PROJECT: City of Coburg

**Johnny Diamond Park**

**Request For Proposal for Landscape Design Services**

ADDENDUM #1

ArcGIS Web Map

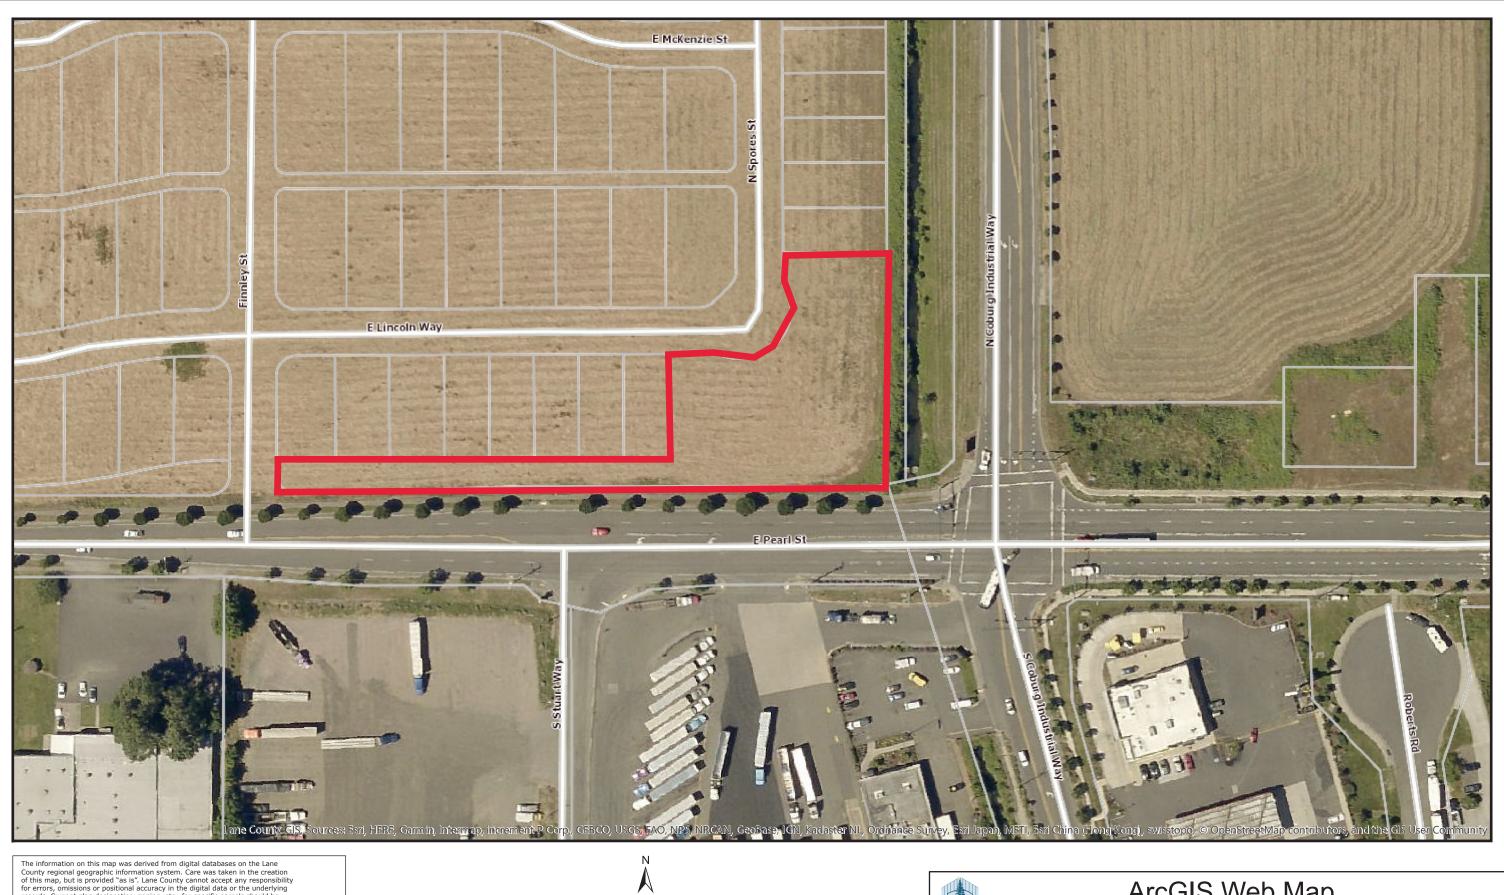
**Project Background** – *Clarification:* – This project is not a Master Planned park. See attached site layout of park limits. The owner will supply an existing conditions survey in a follow up Addendum. The owner will provide any and all civil engineering for conveyance and/or disposal of stormwater.
